PLANNING BOARD

Tuesday, January 9, 2024 at 4:30 PM
Hybrid Meeting, Room 24 (Basement
Level of City Hall) and Zoom

- ii. Major Site Plan and Conditional Use; 19 West Street; Carleton West, LLC, Applicant. The Planning Board will hold a hybrid public hearing to consider a proposal to redevelop an 8,360 square foot medical office building as a five-unit residential building, and construct two separate duplex structures on a 0.86-acre property addressed at 19 West Street, with frontage on Carleton Street. The project also involves the construction of 18 new parking spaces, and would further retain 23 existing parking spaces for use by neighborhood residents. The property is zoned R-6 residential, and is also located within the West End Historic District. A project and plan summary are available for viewing on the city's CSS Portal (<https://css.portlandmaine.gov/>) by referencing Plan Number PL-002614-2023 and CU-002693-2023.

Prepared For:		Consultant:		Architect: ARCHETYPE ARCHITECTS 48 Union Wharf Portland, Maine 04101 207.772.6022 archetype@archetypepa.com	Project: 19 WEST ST. PORTLAND, MAINE	Revisions:	Date: 12-4-2023	Scale: 1/4" = 1'-0"	Townhouses Roof Plan	A1.05

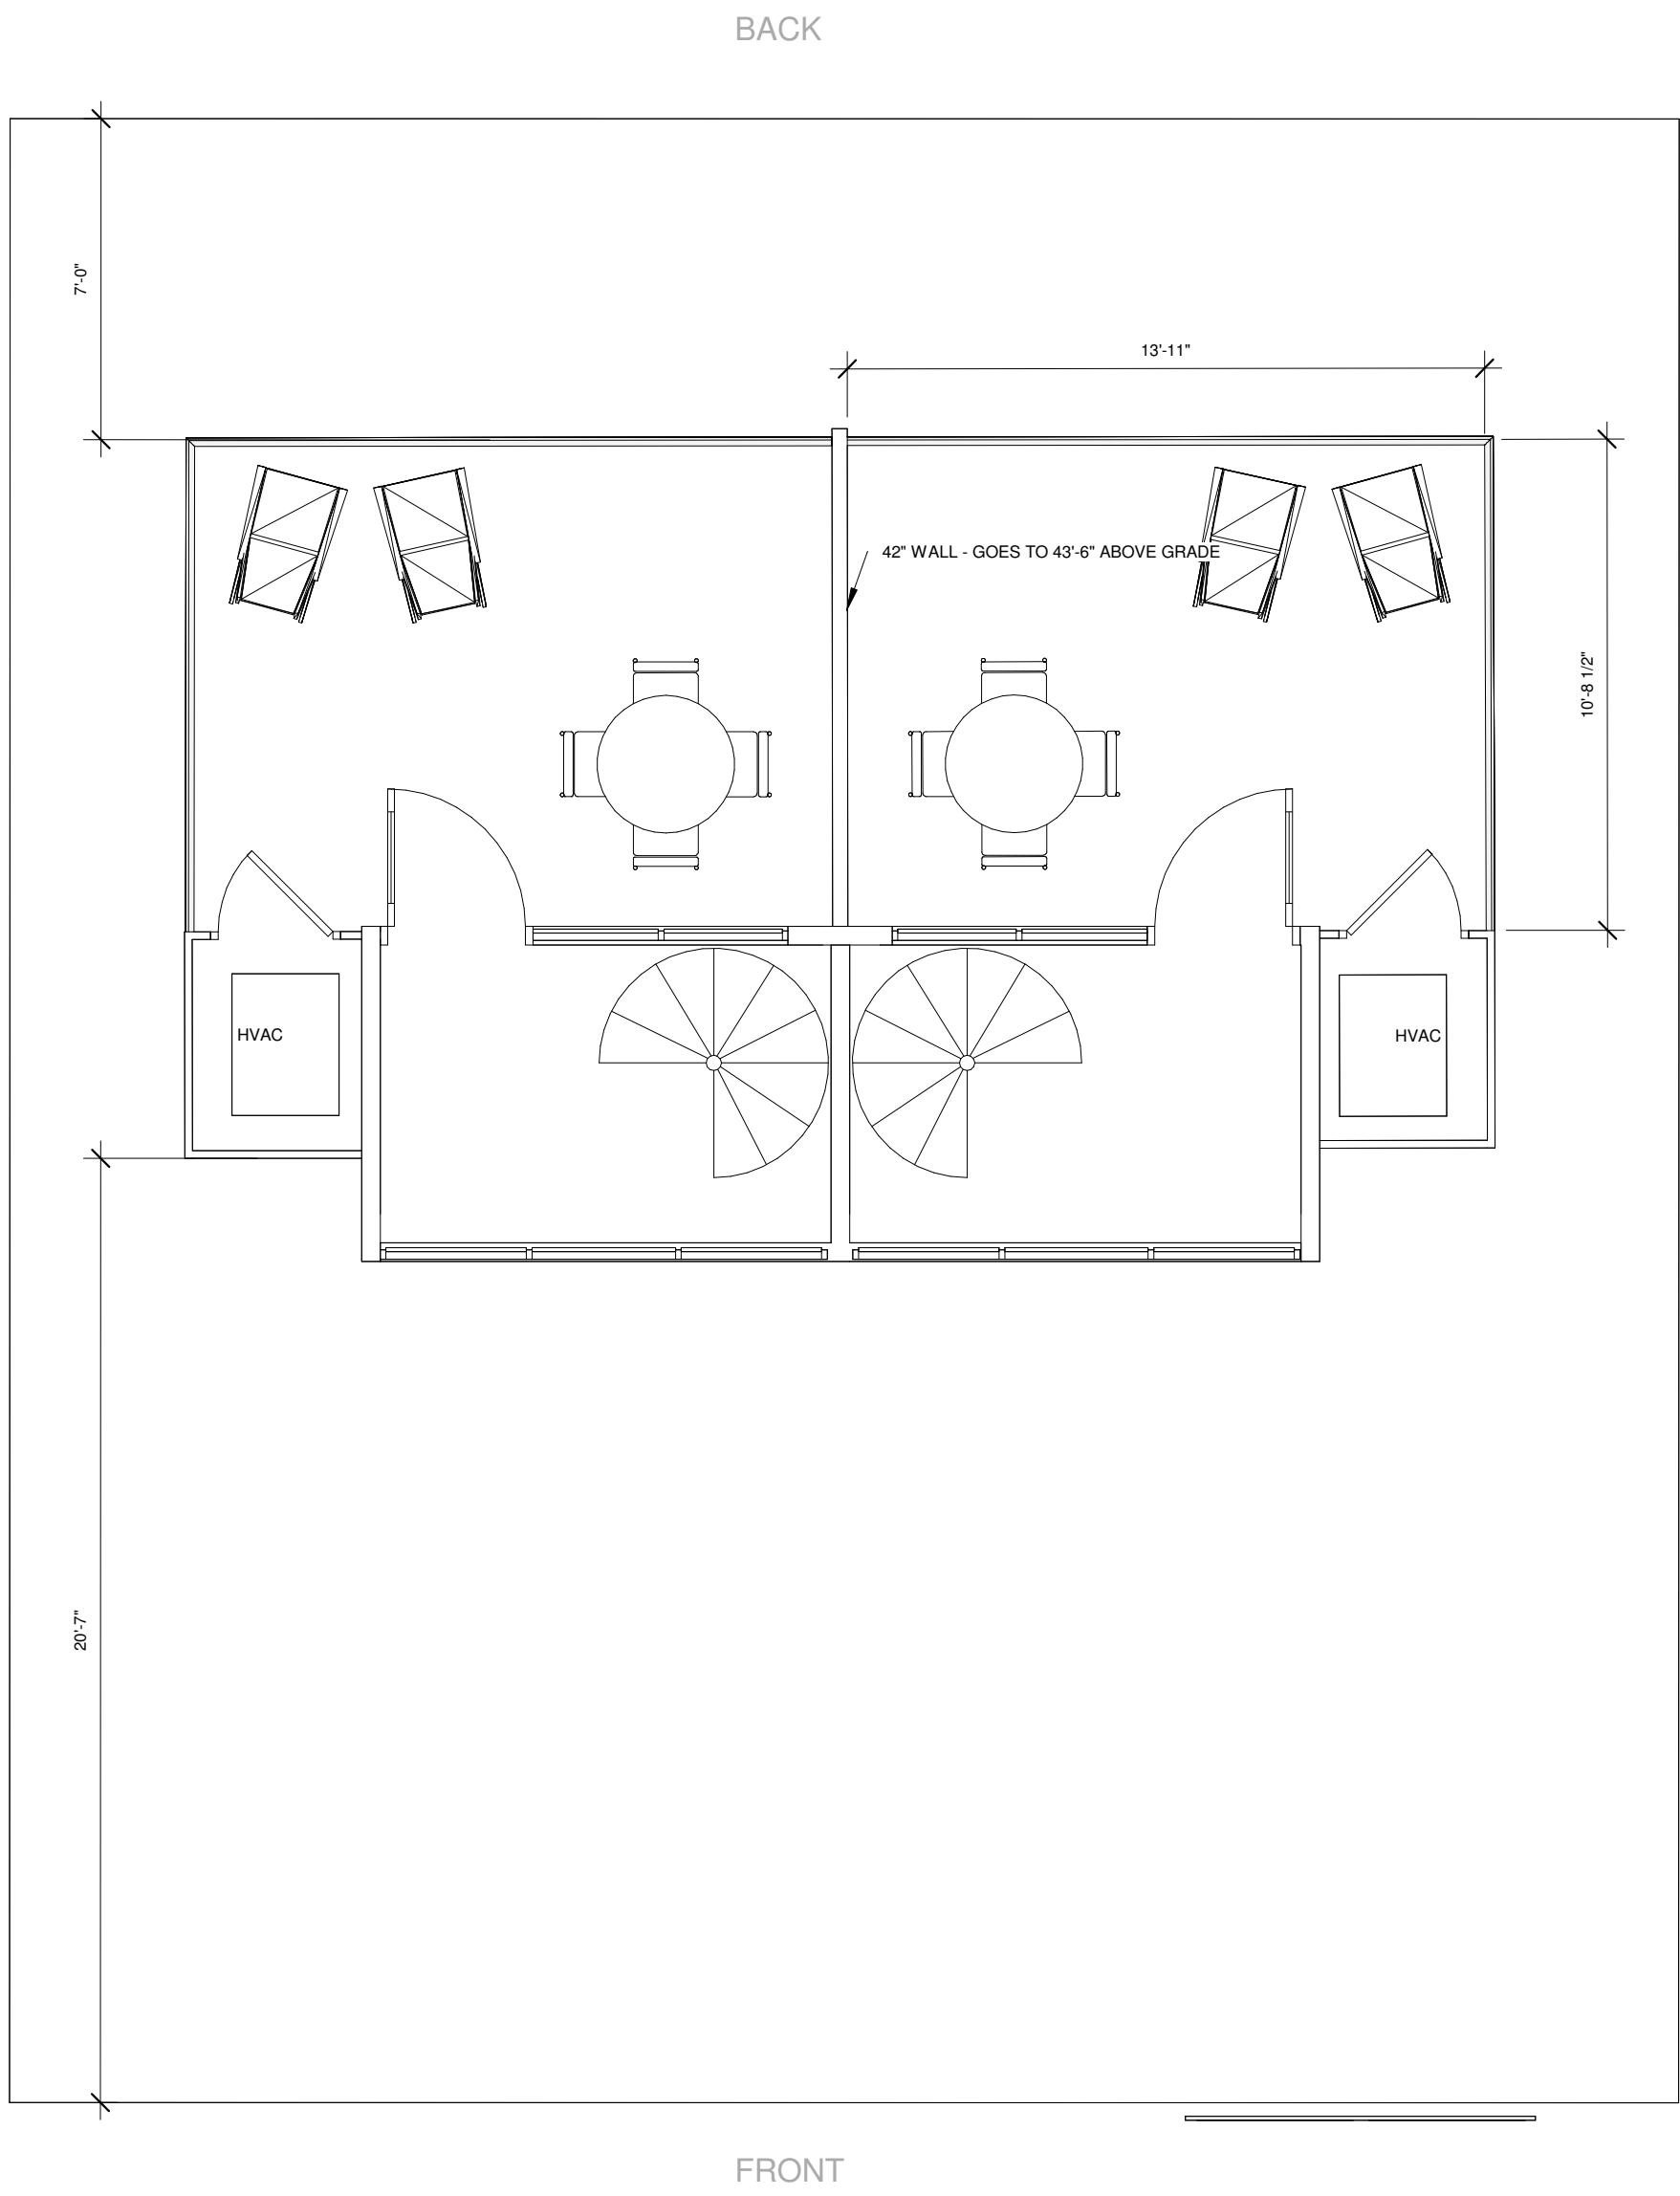
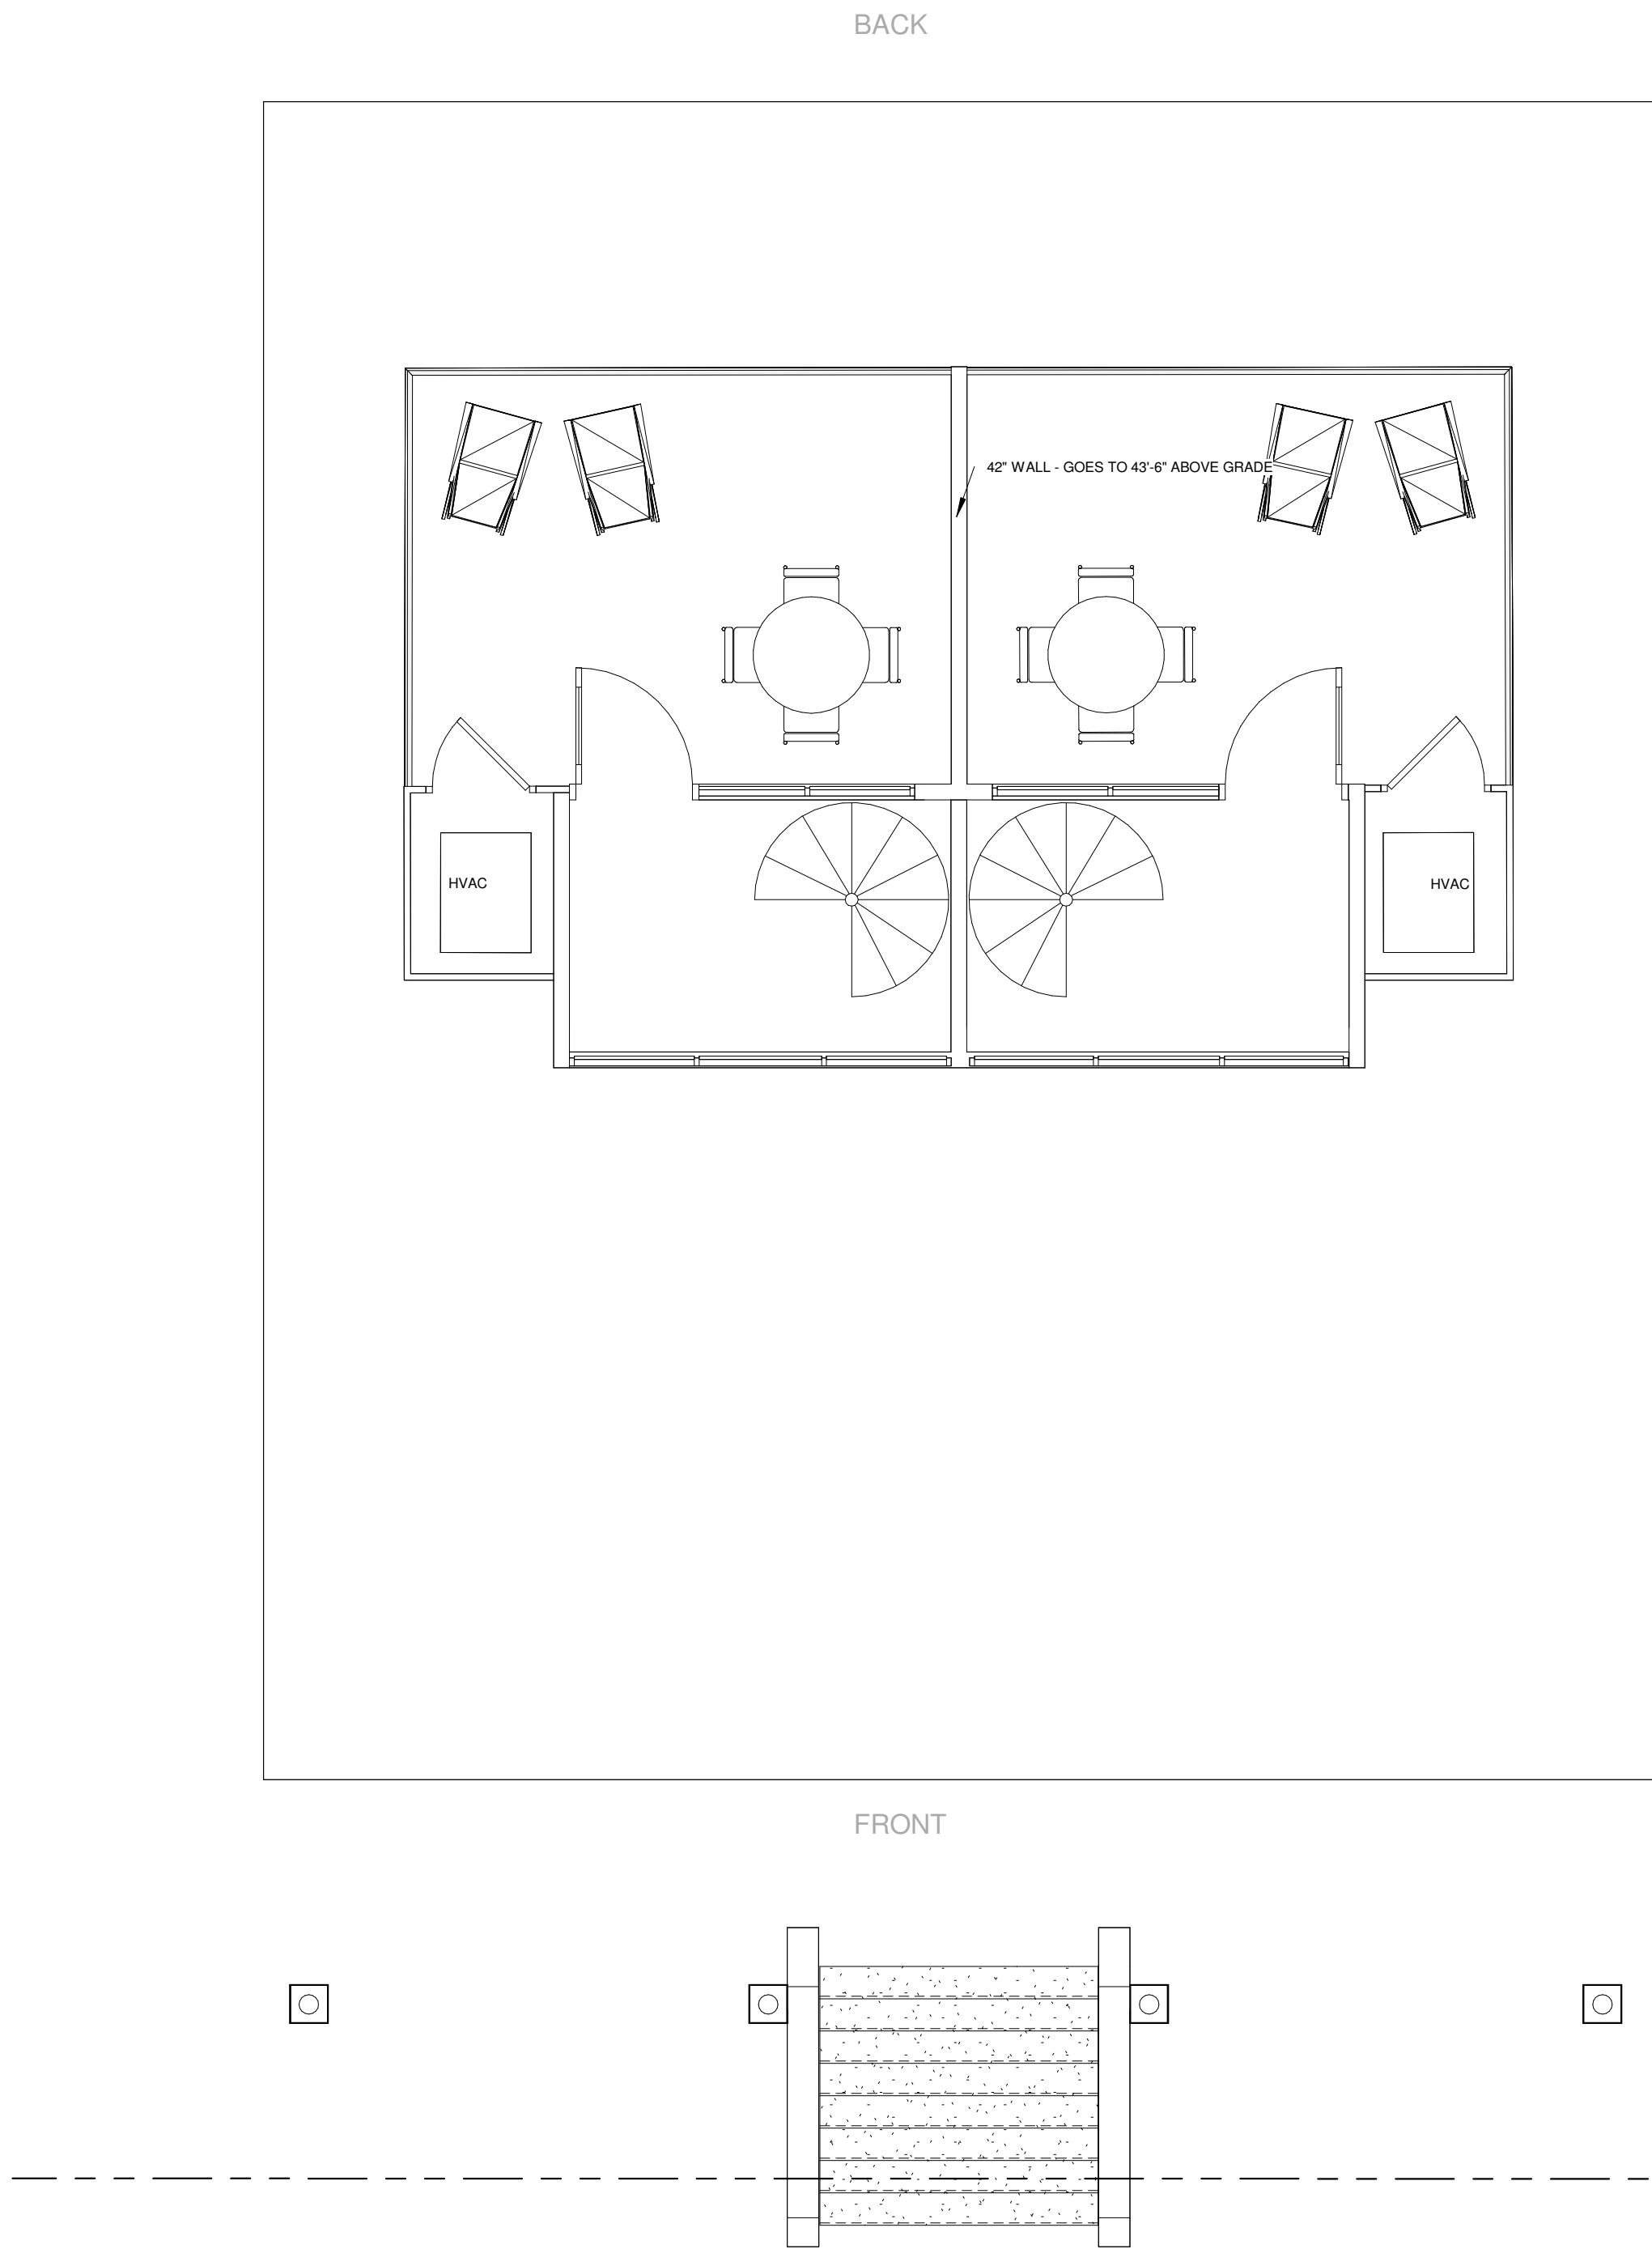
- The roof plan for the townhouse A1.05 shows a smaller footprint for the stair towers on the townhouses but the stairs appear to be a spiral stair (round figure) but the fourth floor does not show a spiral stair. Also, what is the line that divides the two decks? It can't be a wall higher than 45' from grade at the top.

Applicant Response: The roof plan has been revised, see A1.04 and A1.05. The roof accesses for the units have now been joined, see A2.01. The wall dividing the decks is a 42" wall which places it at 43'-6" above grade.

Revised Plans: A1.04, A1.05, A2.01
